RECOMMENDATION MEETING (#3034058-EG)

August 28, 2020

1766 NW MARKET STREET, SEATTLE, WA 98107

Construction of a new 85' eight story Type IV-C mass timber (CLT) hotel. With six floors of 120 upscale guestrooms, a double height CLT jewel box amenity at the ground floor with outdoor open space, a roof deck for hotel guests, and one floor of below grade parking with 30 stalls. The main hotel entrance will be located on the southeast corner of the site on NW Market St, and an outdoor dining area to the southwest. Access to the below grade parking levels will be from the alley to the North.

DRB - ELEVATION AND PLAN

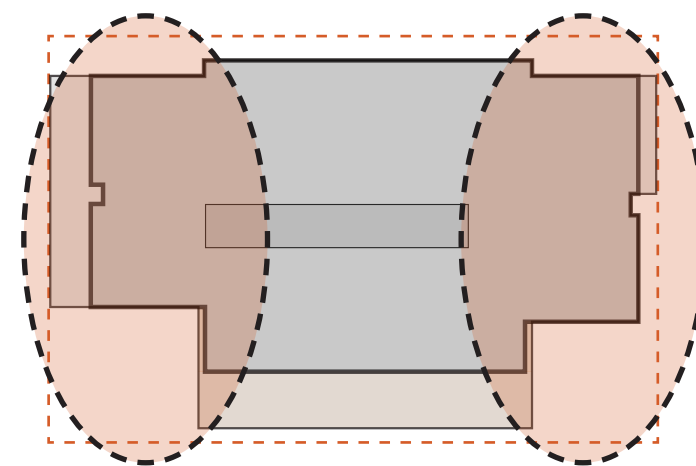
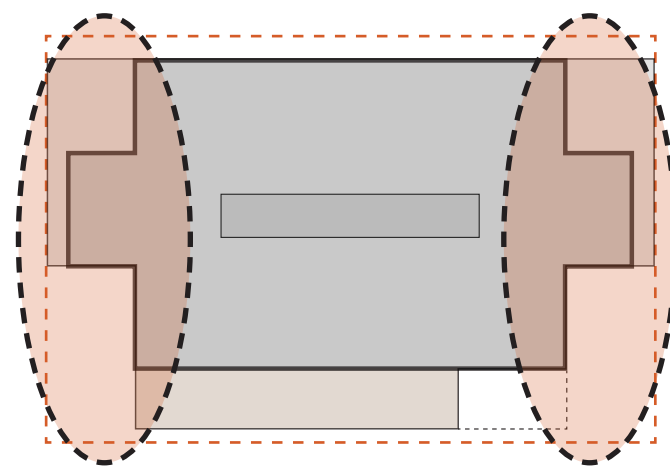
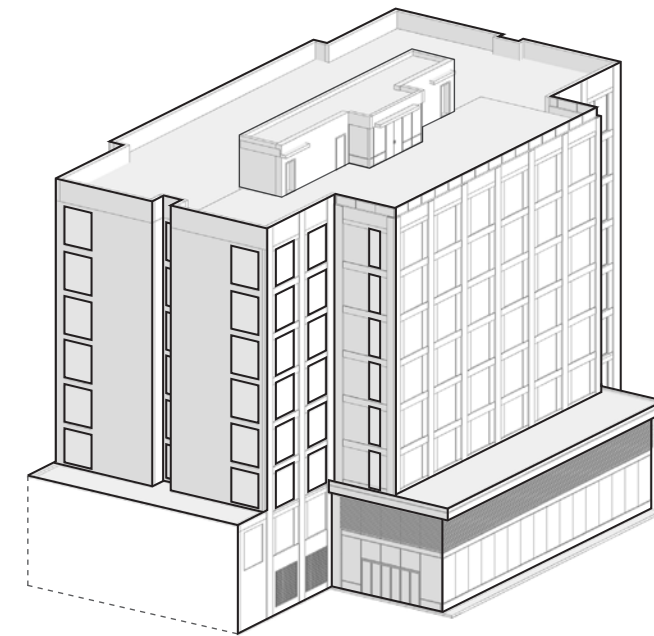
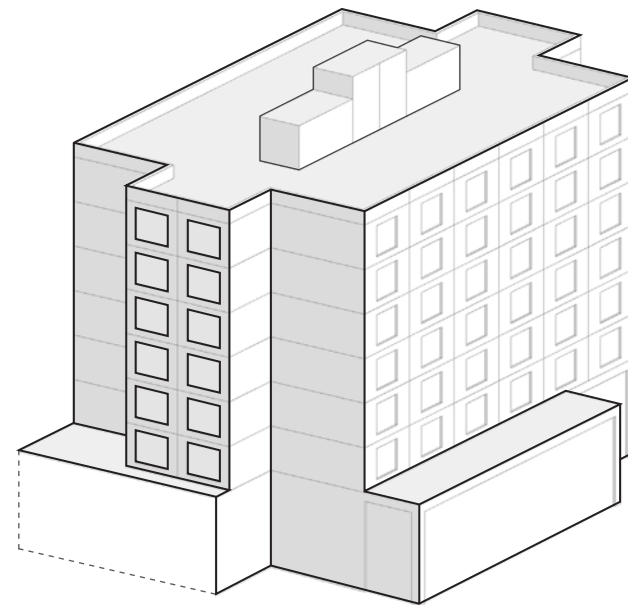
BOARD GUIDANCE | Supported the minimized blank wall conditions along the East and West lot lines resulting from pulling back and incorporating glazing and modulation.

RESPONSE | By pulling back the east and west facades above the podium 5' and 11' respectively, and adding a vertical notch on both elevations, we're providing light and air for our building and the neighbors. These facades incorporate large windows and material changes that compliment the street-facing elevation. The massing at the podium creates a connection along the street level and a unified scale with the adjacent structures.

DRB - ALLEY AND STREET SETBACKS

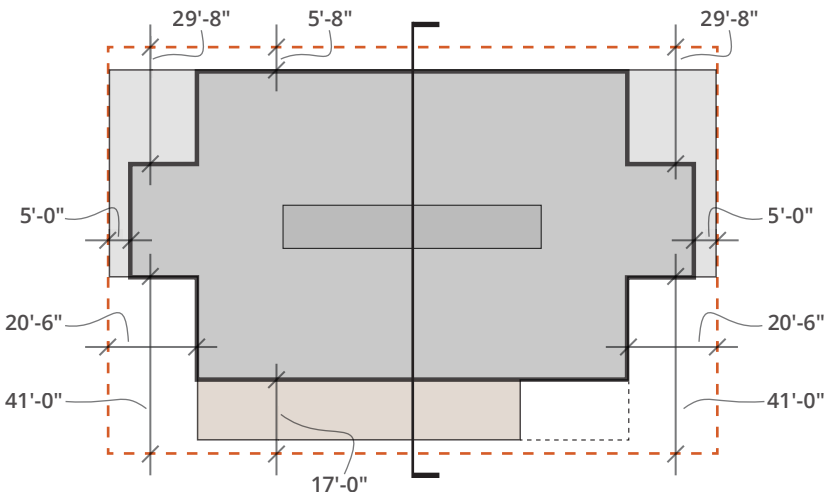
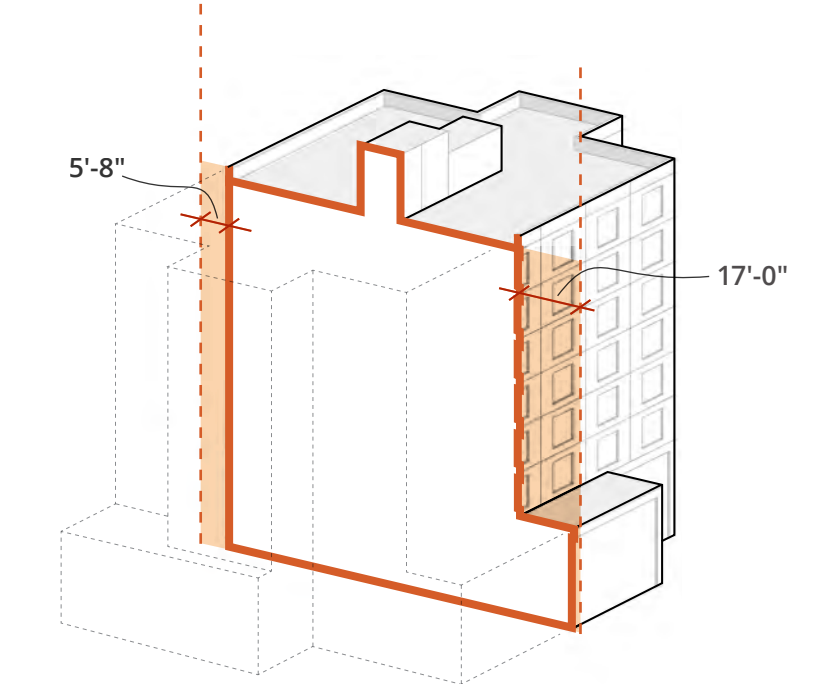
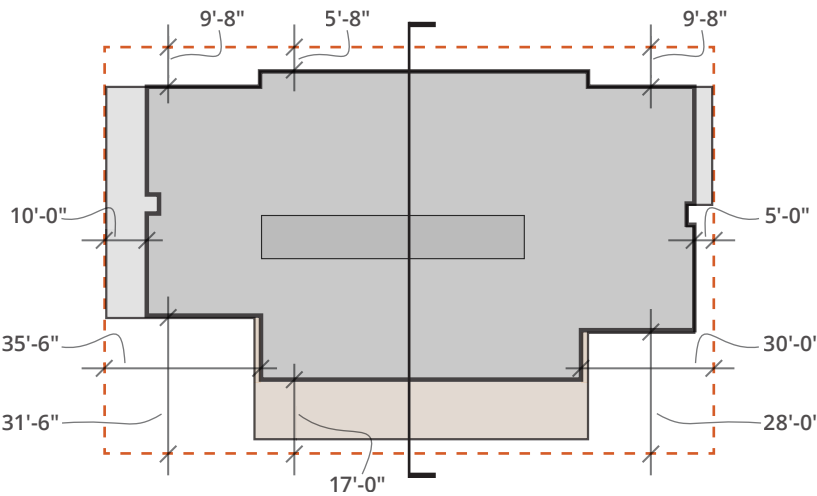
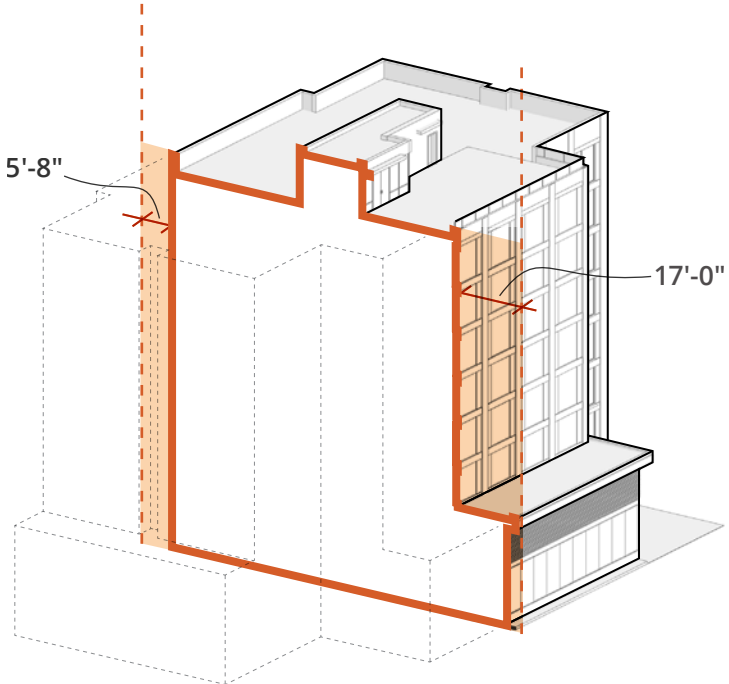
BOARD GUIDANCE | Supported the greater upper-level setbacks along Market Street as opposed to providing more setback along the alley, as this option reduced the scale and provided more massing relief along Market Street.

RESPONSE | Along the alley and Market Street, we're maintaining the supported setback strategies from EDG. The rest of the setbacks help to distinguish the CLT jewel box and the outdoor plazas at ground level from the upper levels. The simplicity of overall form anticipates the zoning opportunities of the neighboring sites, creating a benchmark for future development.

DRB - GROUND LEVEL PROGRAMMING

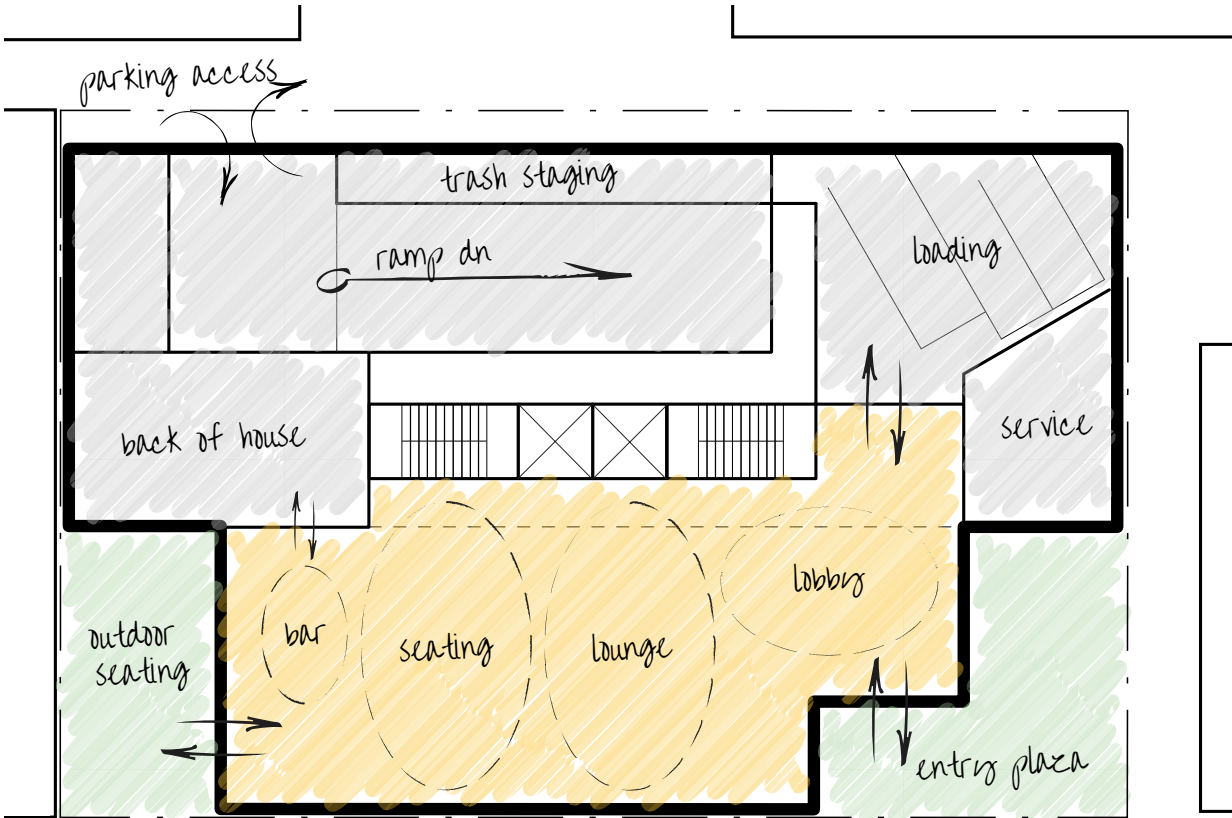
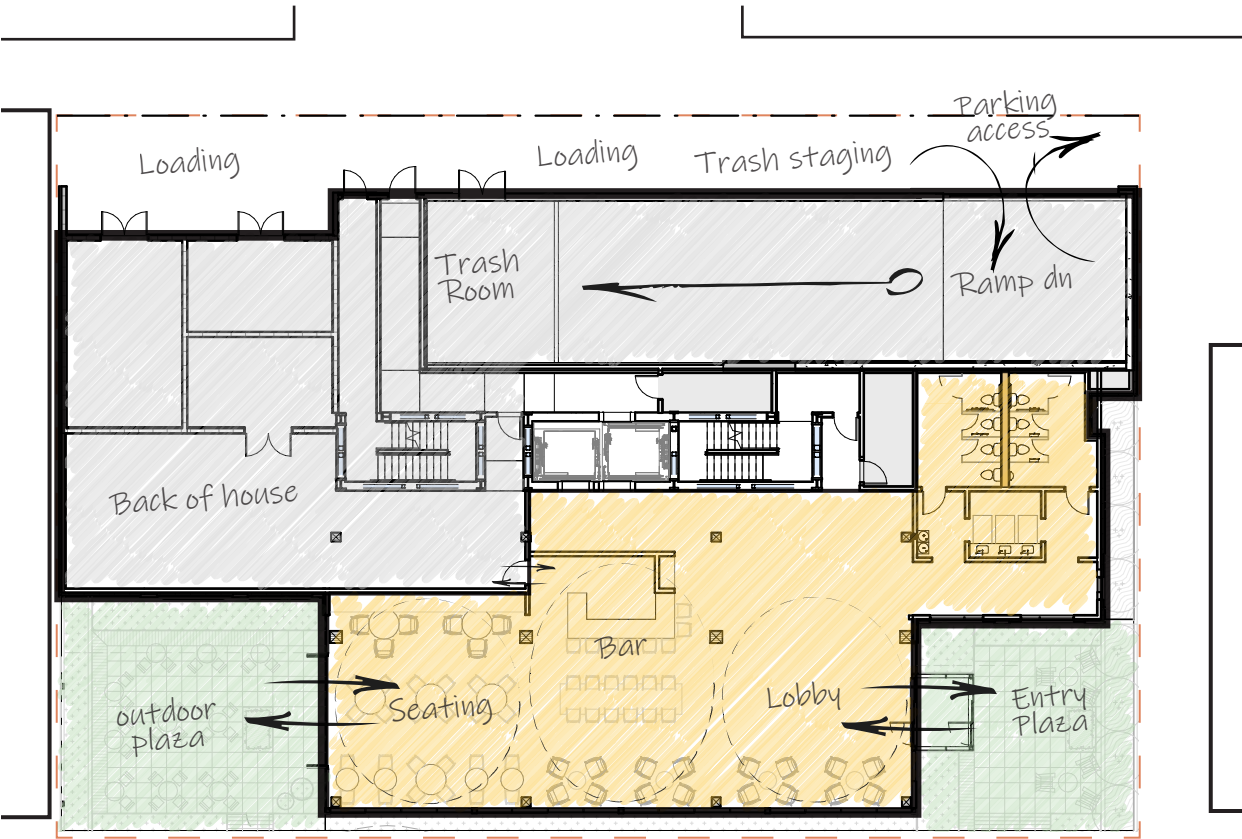
BOARD GUIDANCE | Supported the concept of carving the street level podium to incorporate an open space design element. However, the board would like to see further development of the ground level and further strengthening and clarifying the relationship of open space and programming.

RESPONSE | We're creating two plazas that blend the 20' wide public sidewalk into the open, double-height amenity space, stitched together with high-quality landscaping and artistic features. To the east, the smaller entry plaza is an extension of the sidewalk, reflecting the idea of the Market Street gateway into Ballard. To the west, the larger dining plaza extends the indoors outdoors toward the neighborhood center. Both plazas will have large, glassy openings into the interior, ensuring that both spaces will be visually connected to the interior and used throughout the year.

DRB - OPEN SPACES

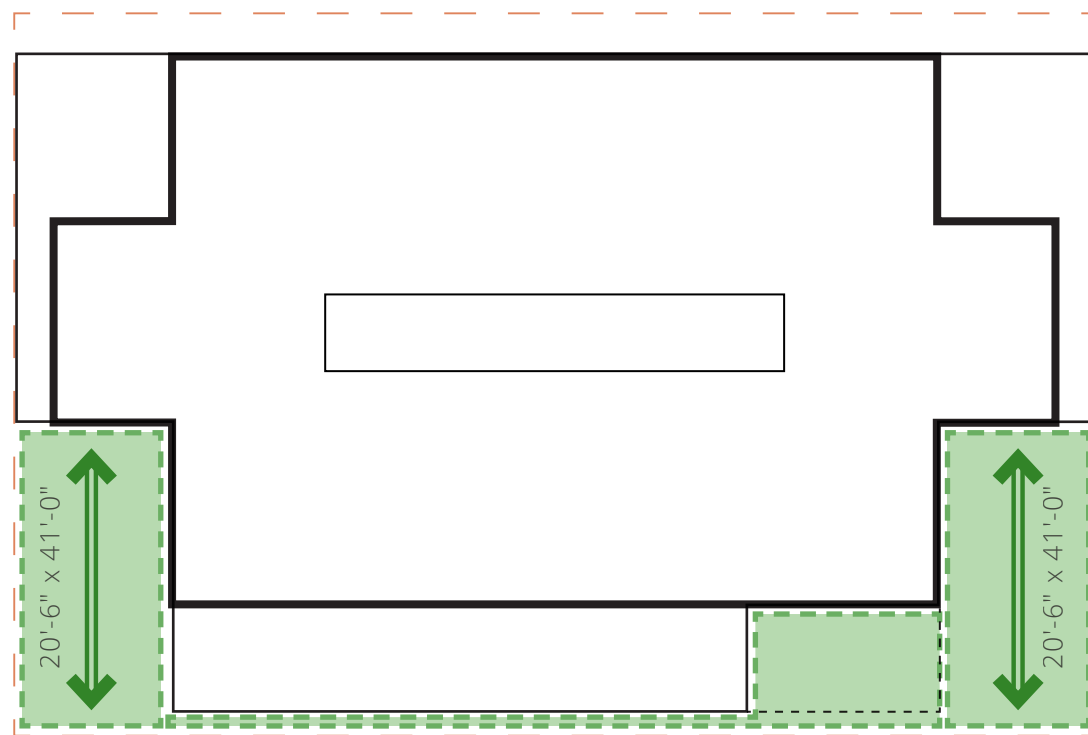
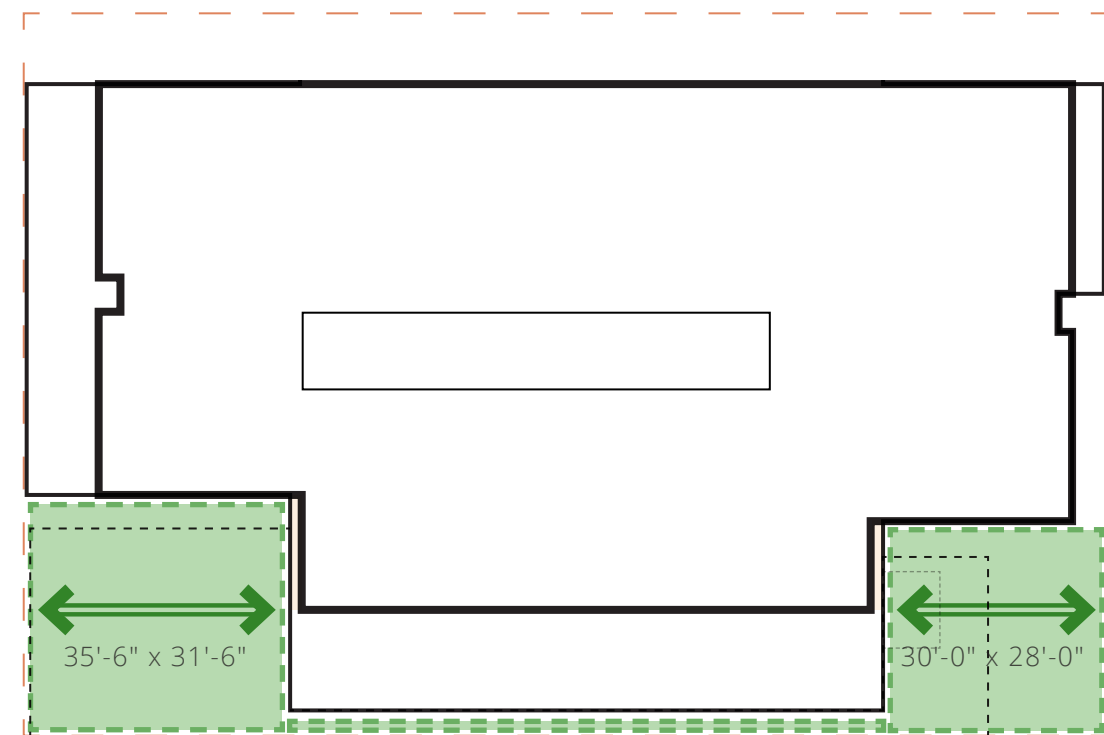
BOARD GUIDANCE | Explore shorter depth and longer open space along NW Market, balanced with a continuous street edge experience. The Board appreciated the podium / facade studies provided on page 30. The Board was intrigued by the potential to maintain the structural expression and create a continuous urban edge while expressing the open space as a void.

BOARD GUIDANCE | Supported orienting the larger open space toward the west, toward the center of Ballard.

RESPONSE | The two south facing open spaces along Market Street are both shallower and longer than Option C at EDG, but they have also been refined to reflect the programmatic requirements of the spaces and bring the uses closer to the connection with the sidewalk.

The western dining plaza is larger and longer than the eastern entry plaza, in order to provide more space to the place where people will gather. This western plaza is oriented to the southwest, toward the center of Ballard. The canopies and landscaping are treated as a single design element that binds the two plazas together and to the CLT jewel box, creating a vibrant street edge.

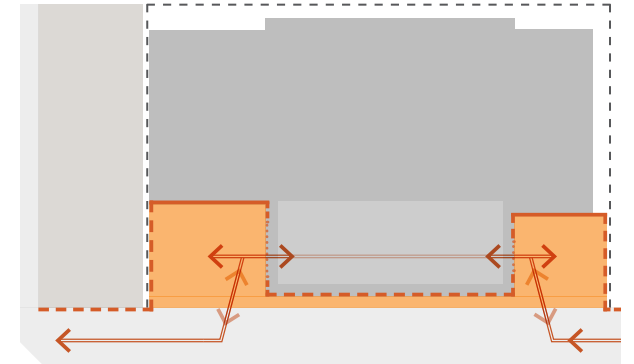
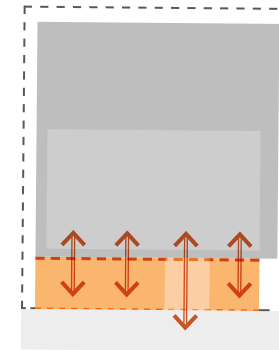
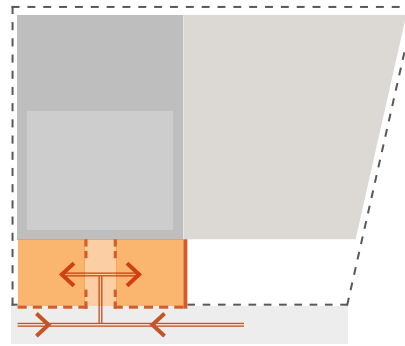
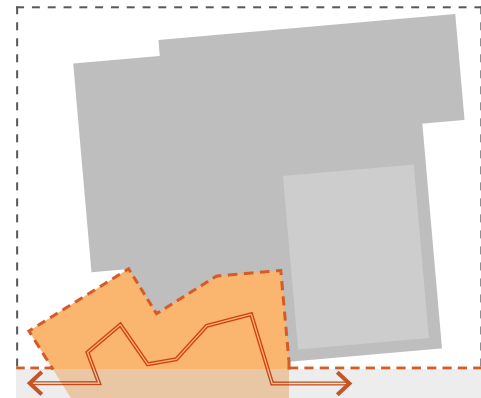
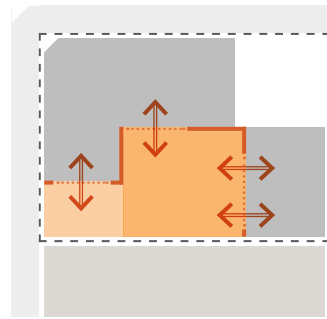
BOARD GUIDANCE | Study other open space/outdoor uses along Market and within the Ballard context, as well as precedents outside of Ballard. Demonstrate how this open space fits into the Ballard character/context.

RESPONSE | It's important for our project to add to the rich variety of open spaces around the neighborhood. Studying four precedents in the area has provided us with practical information about how to connect the outdoor spaces to the sidewalk and building entries. We've used these precedents to connect the outdoor spaces to the sidewalk, provide multiple pedestrian connections to the sidewalk, and to use the form of the building to define the outdoor spaces.
